HISTORIC PRESERVATION COMMISSION

TO:	Mitra Pedoeem
	Department of Permitting Services
FROM:	Rebeccah Ballo
	Historic Preservation Section
	Maryland-National Capital Park & Planning Commission
SUBJECT:	Historic Area Work Permit #1008218: Hardscape alteration and fence installation

Applicant:Kyle Rabe (Lila Fendrick, Architect)Address:3706 Bradley Lane, Chevy Chase

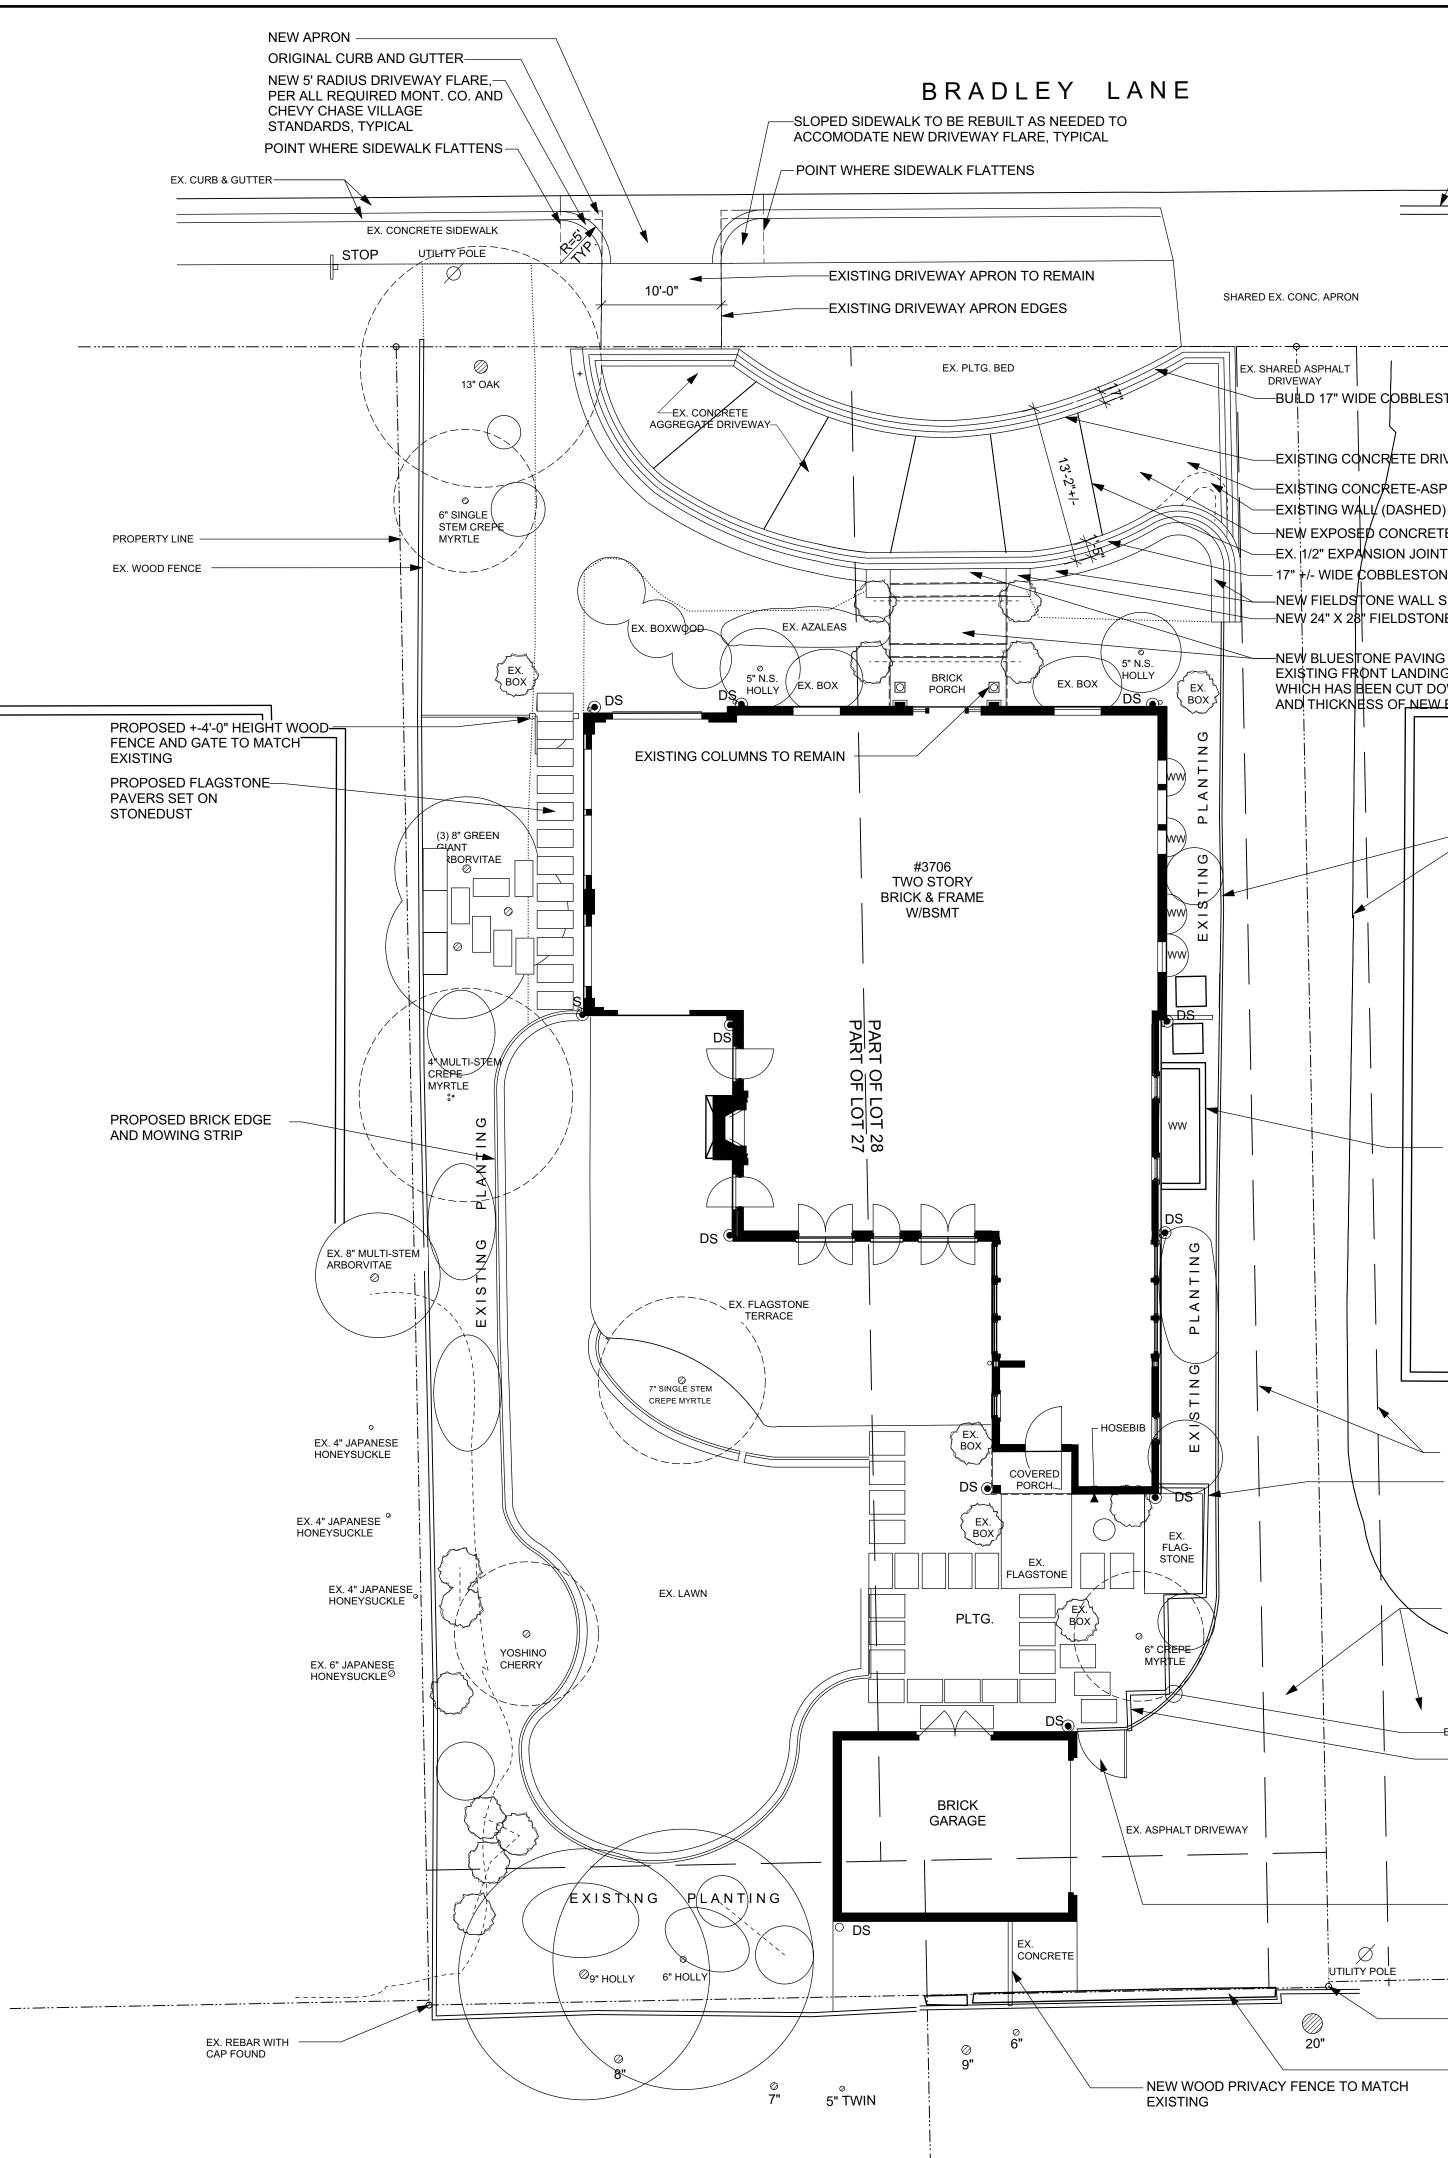
IOVED L TO BE REMOVED OVED; EXISTING FOOTING DEPTH TO REMAIN IOVED	APPROVED Montgomery Count Historic Preservation Com Manual Manual REVIEWED By Rebeccah Ballo at 9: ALL FENCES TO BE NO MORE THAN 6' HEIGHT PER HPC CONDITION OF APPROVAL	mission MUA	2022	LILA FENDRICK landscape architecture & garden design 6904 West Avenue Chevy Chase, Maryland 20815 (301) 907-7700
ONCRETE POUR OF TOP PORCH LANDING EWAY EDGES				And A CHEVY CHASE, MD 20815
7143				No. Date Revision Notes Image: Constraint of the second secon
		 ∅ +(99.5) +99.5 (100) G W S OHL S ∅ □ □	KEYEXISTING TREESPROPERTY LINEEXISTING ELEVATIONPROPOSED ELEVATIONEXISTING CONTOURPROPOSED CONTOURGAS LINEWATER LINESEWER LINEOVERHEAD LINESEWER MAN HOLEPOWER POLELIGHT POLESIGNEX. METAL FENCEPROP. WOOD FENCETO BE TRANSPLANTEDTO BE REMOVEDLANDSCAPE CONTRACTORGENERAL CONTRACTOROWNSPOUTAREA DRAINHOSE BIB	SURVEYS, 03/22 General Notes I. For location of utilities, call "Miss Utility" at 1-800-257-7777, or log on to www.missutility.net/itic 48 hours in advance of any work in this vicinity. the excavator must notify all public utility companies with under ground facilities in the area of proposed excavation and have those facilities located by the utility companies prior to commencing excavation. the excavator is responsible for compliance with the requirements of the local jurisdiction. 2. All subsurface pipes to be rigid PVC pipe. Sheet Title Existing Conditons and Demolition Plan Date 2022-10-11 Scale 1/8"=1'-0" Sheet No.

Plan of Proposed Fencing Runs.pdf

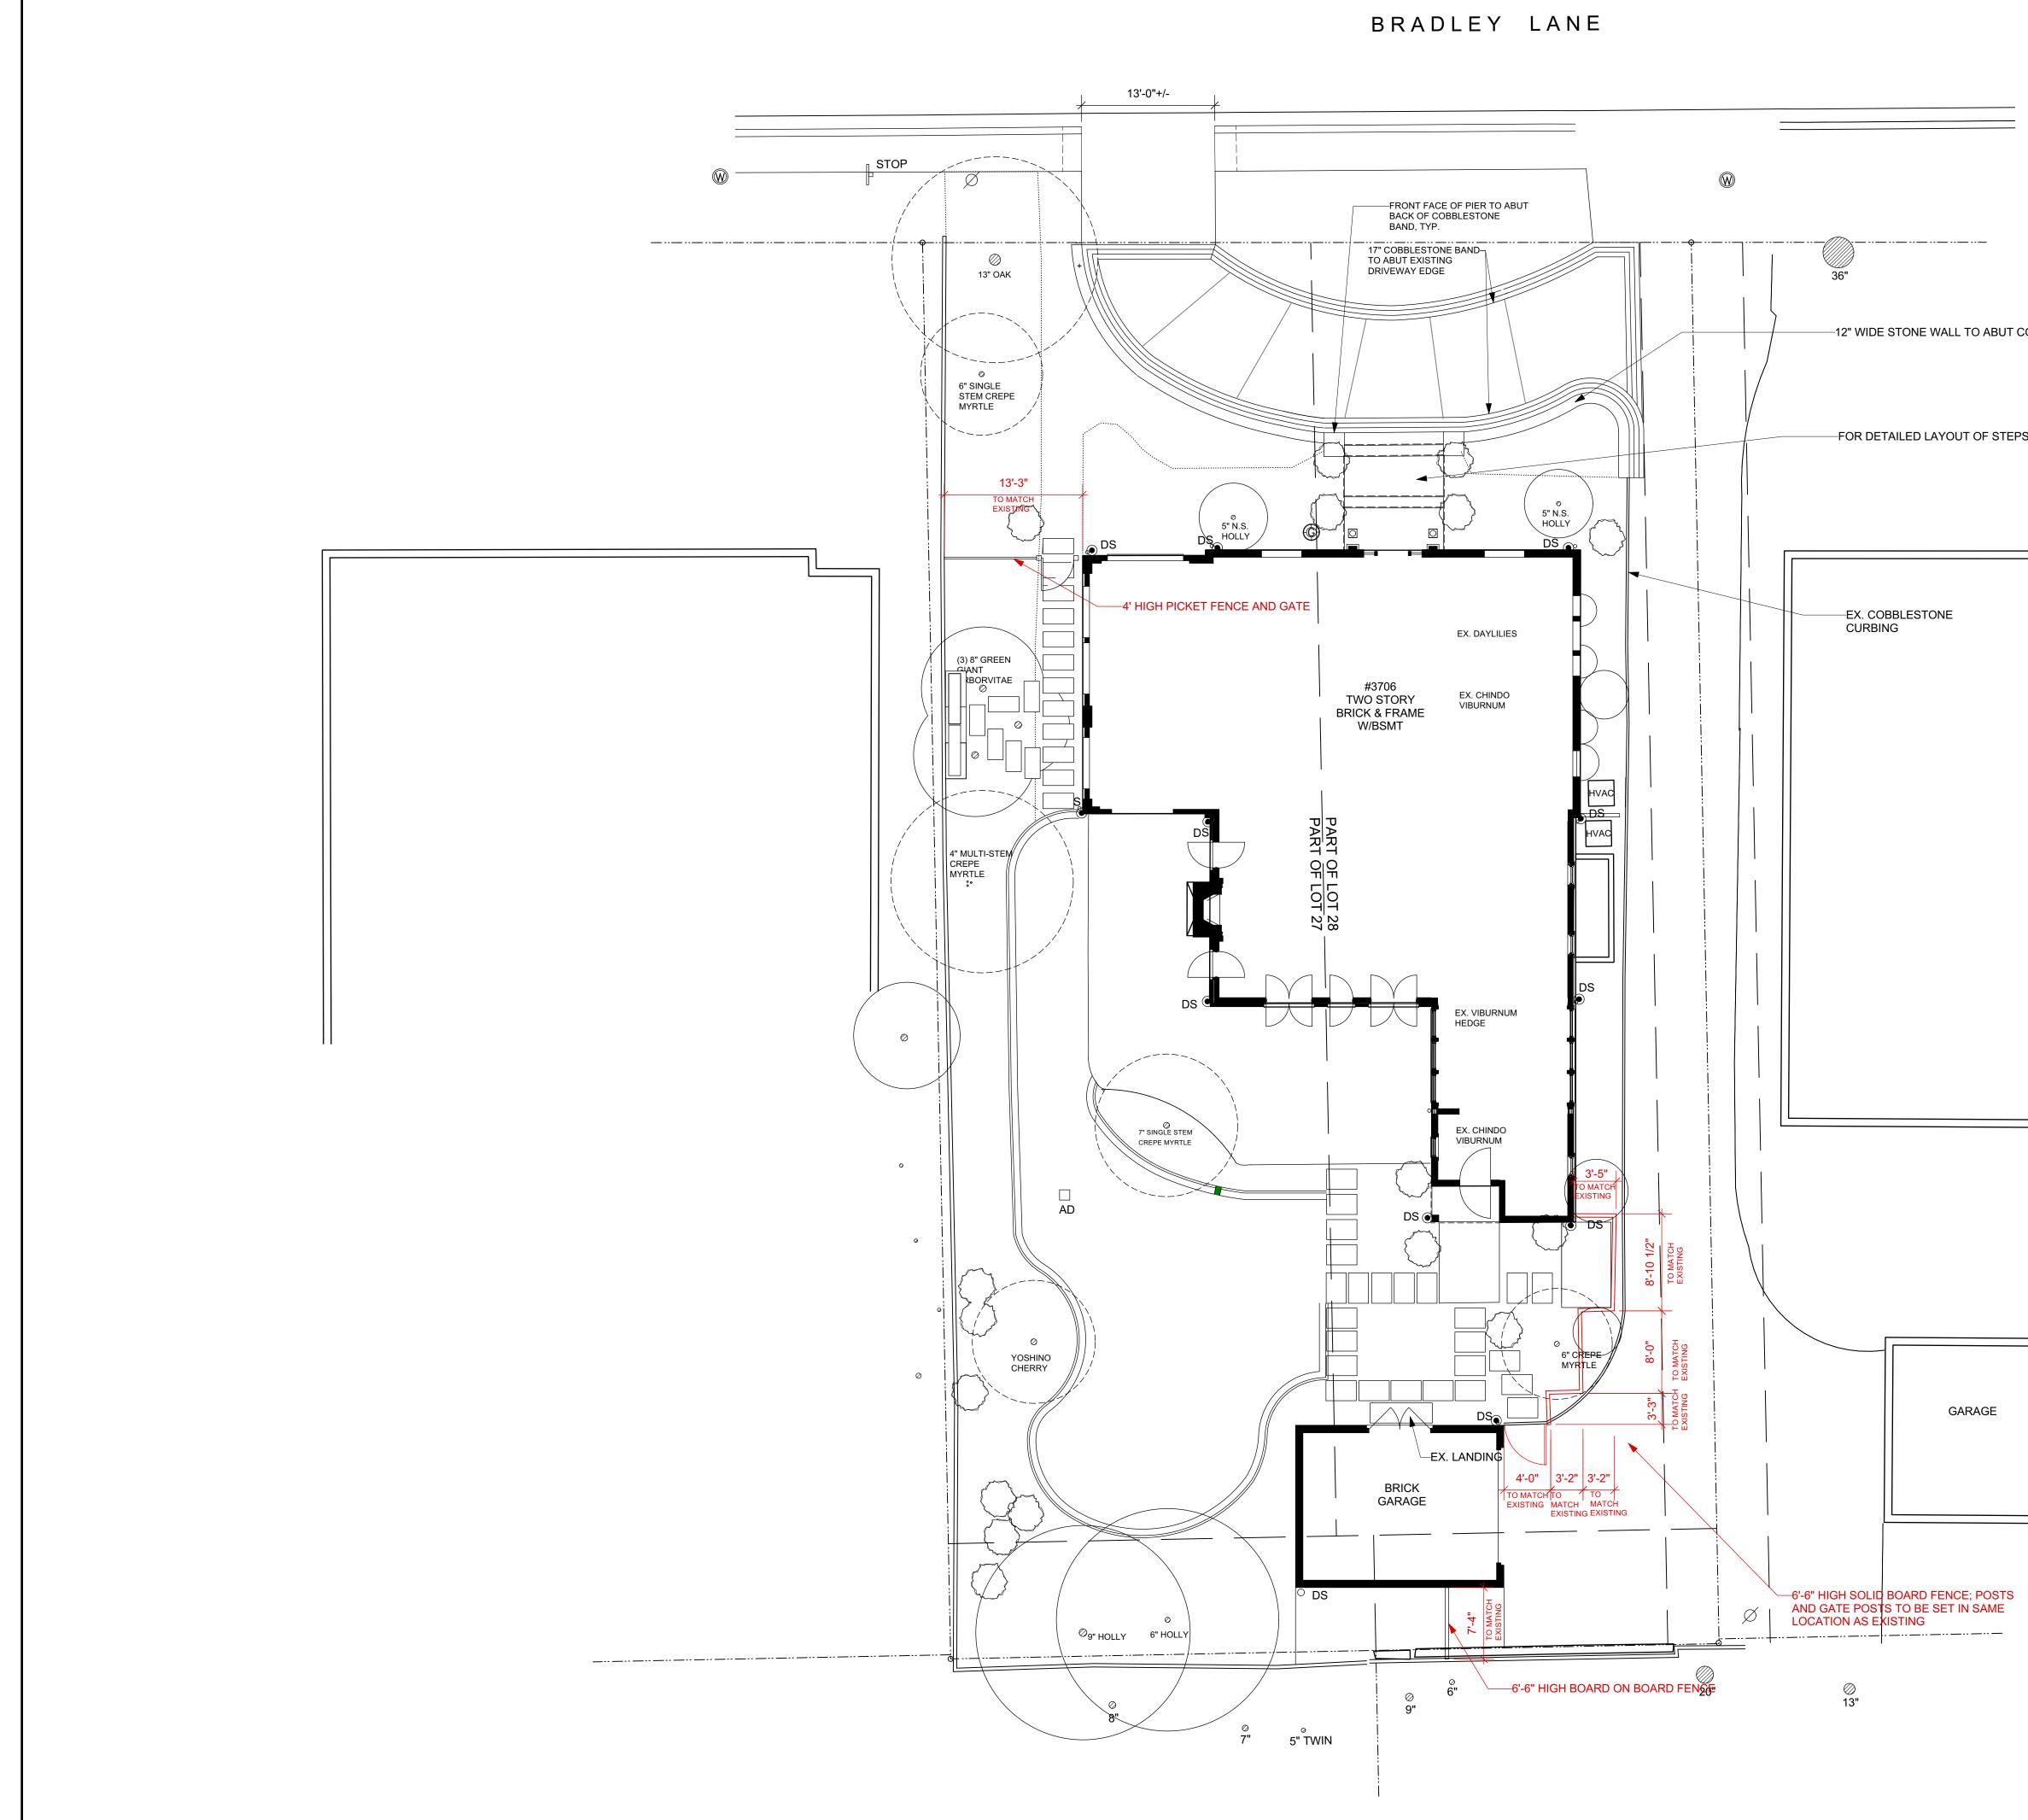
ALL FENCES TO BE NO MORE THAN 6' HEIGHT PER HPC CONDITION OF APPROVAL
